Presentation to Carp River Restoration Project  
Project Advisory Committee – Third Party Review  
October 6, 2008

Ted Cooper, M.A.Sc., P.Eng.  
[taee.cooper@sympatico.ca](mailto:taee.cooper@sympatico.ca)

**Uncompensated Fill / Encroachment  
Since 1983 FP Mapping**

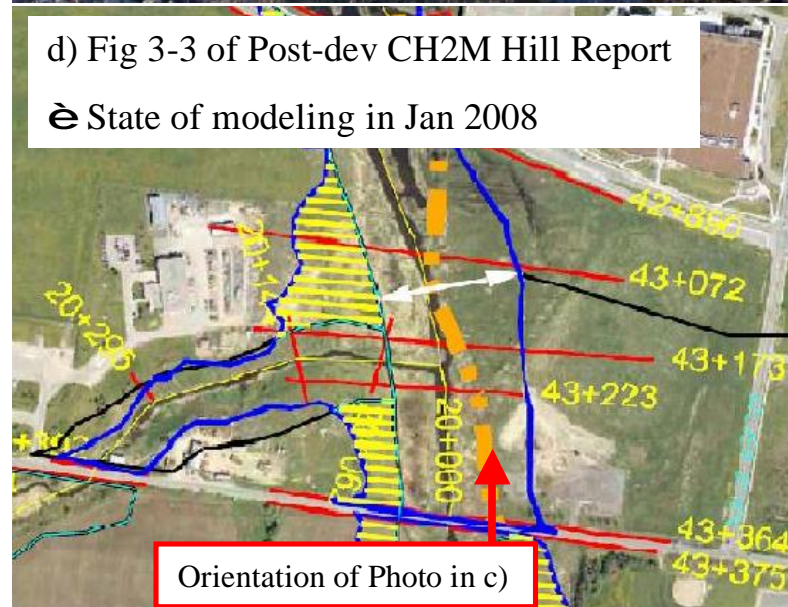
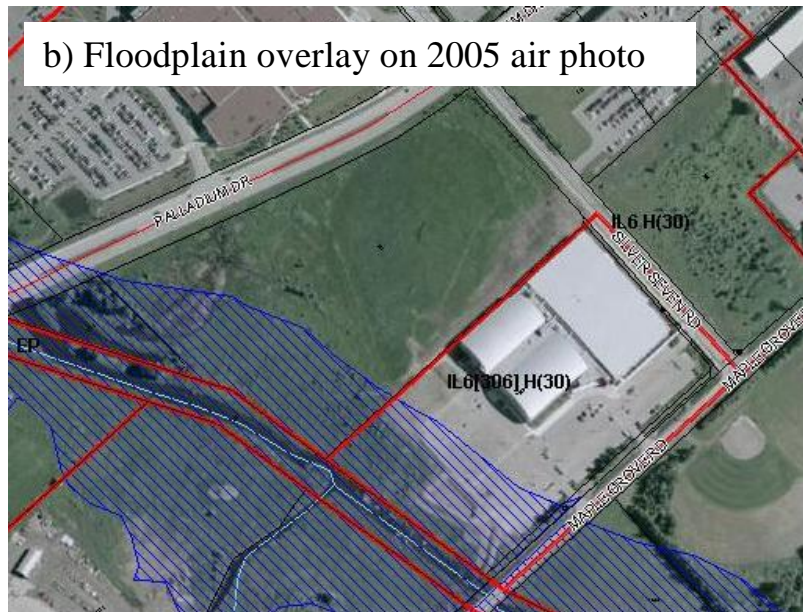
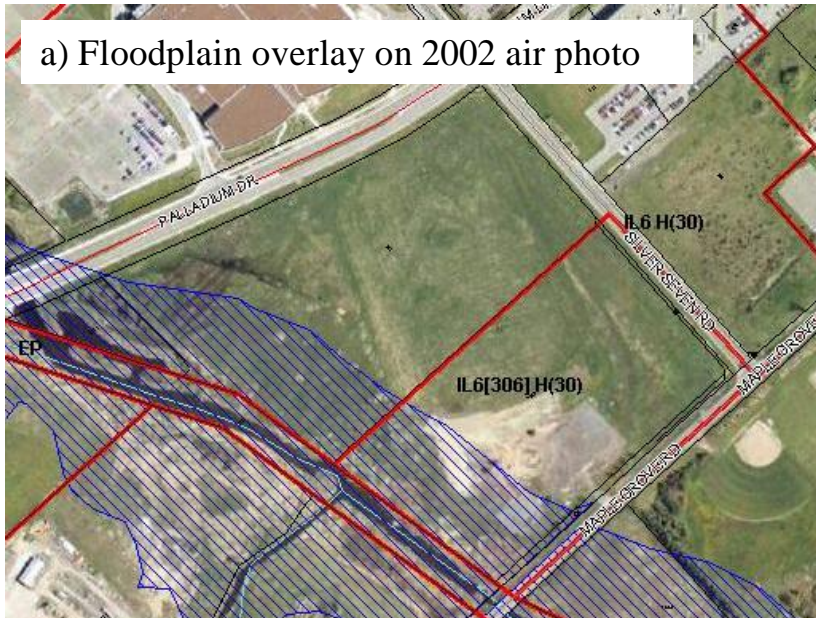
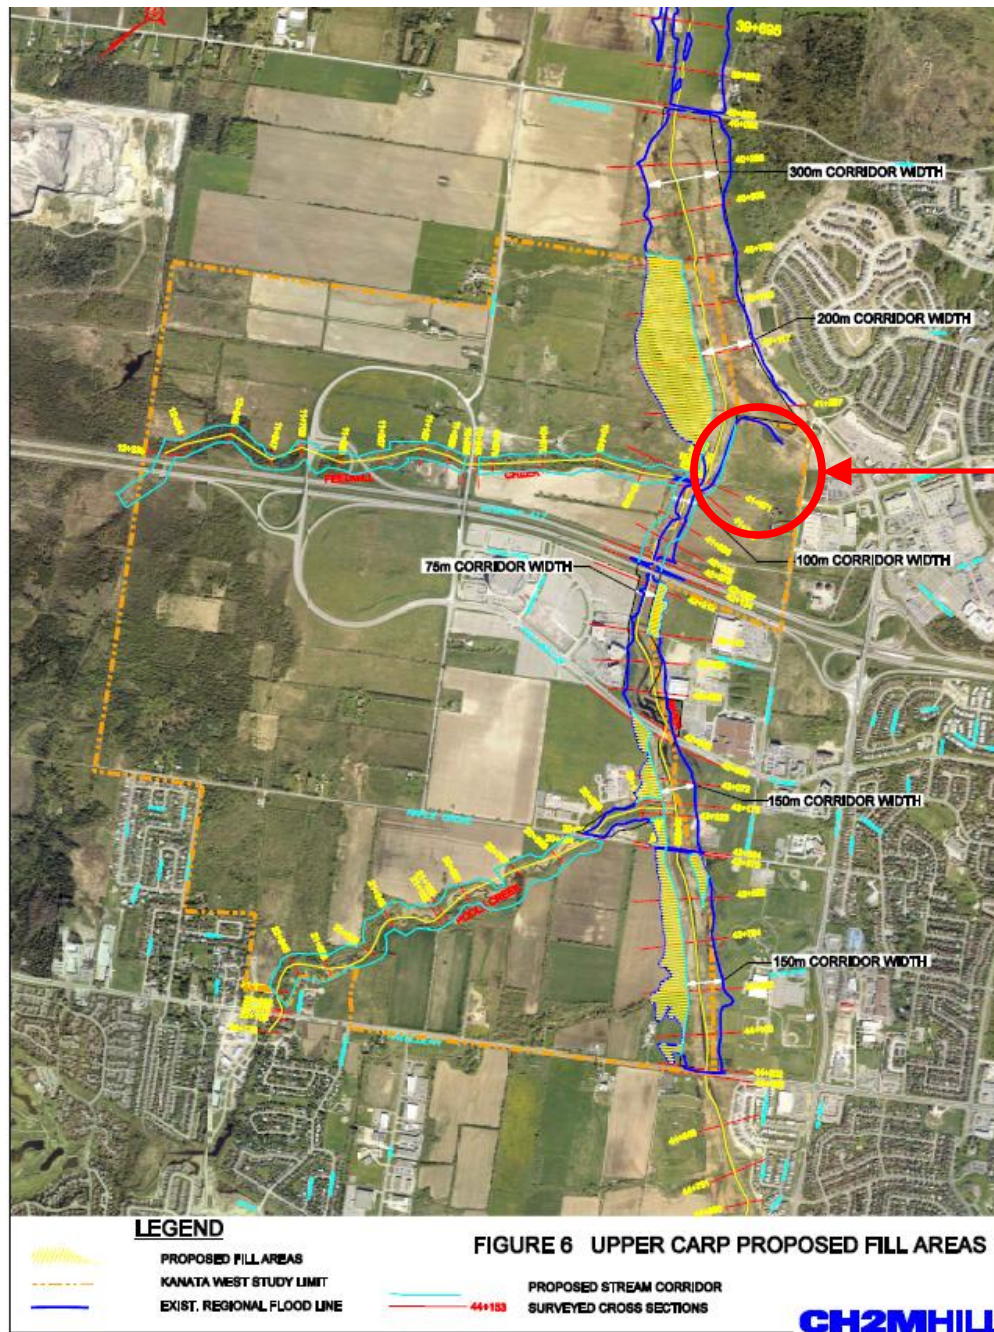
Impact assessment has been complicated because of previous encroachments into the Carp River floodplain that have been approved in a piecemeal fashion.

è How is the existing condition to be defined from which impacts of Restoration Project are to be assessed?

- A – West Creek Meadows
- B – Sensplex
- C - SMART Technologies
- D – Vorlex
- E – ‘Palladium’ Site
- F – Ex. Terry Fox Dr. Ex.

G – 20 Frank Nighbor

H – Terry Fox Drive Extension

# Example of Unaccounted Encroachment – Sensplex & SMART Technologies

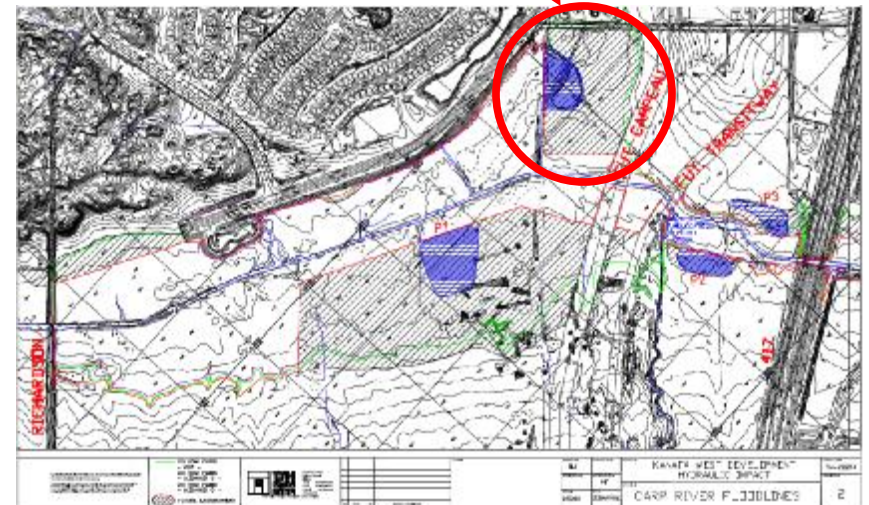
Updated topography reveals other low lying areas should be added to 1983 floodplain area

**Piecemeal approach and approval of development involving 1000's m<sup>3</sup> of fill of Regulated floodplain is inconsistent with Mining and Lands Commissioner's Decisions**

**FIGURE 3-3: Carp River - "Hurricane Frances" September 9, 2004  
Water Levels (Recorded & Modeled)**

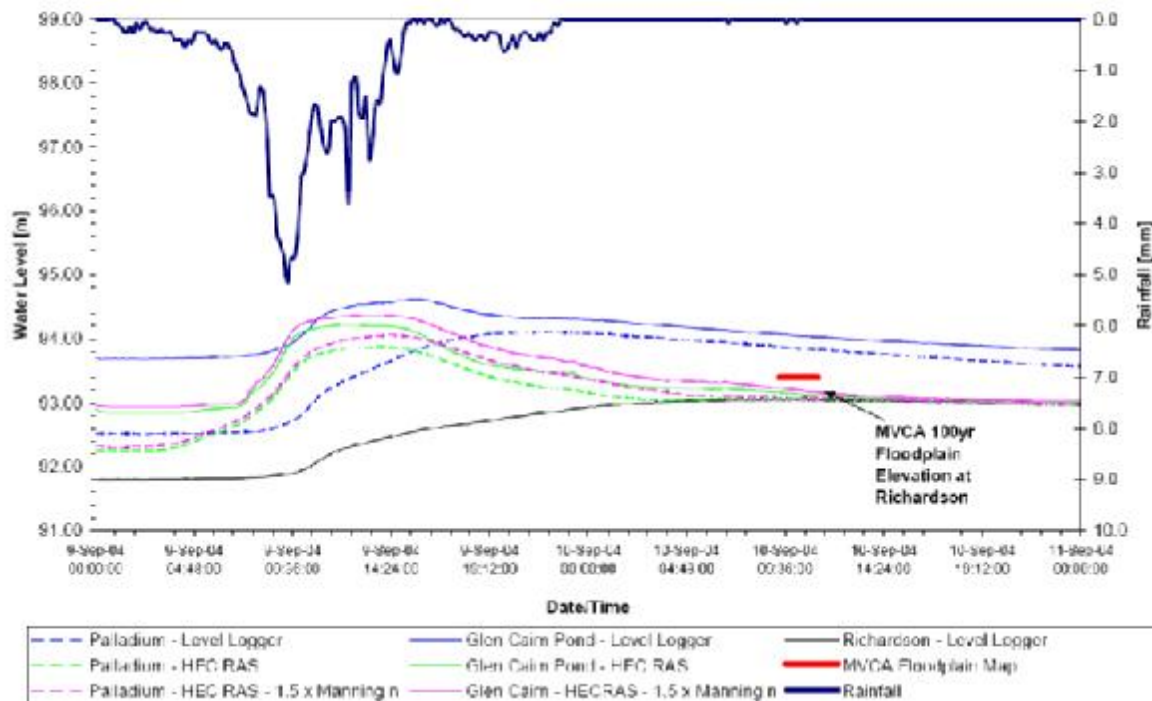
- 4) routing calculations are provided which conclusively demonstrate that there would be no increase in downstream peak flows and total storage has been maintained or increased.
  - è Figure 3.3 of CH2M Hill Existing Conditions Report demonstrates poor model calibration of Sept 9 2004 event – cannot conclusively demonstrate storage or travel time criteria satisfied

Note the large difference between the level logger observations and the HEC RAS predicted levels and time to peak level at Palladium Drive and at Glen Cairn Pond. (Results at Richardson Road not provided in report figure).

The difference is as much as 1m or more for days and days - suggesting a very poorly calibrated model - particularly when this is the fundamental issue - the difference is a measurement of how accurate the computer models simulate floodplain storage.

**Main problem is the insufficient outlet downstream of Richardson Sideroad:**

è Main error in model calibration – model over-estimates conveyance capacity of downstream channel
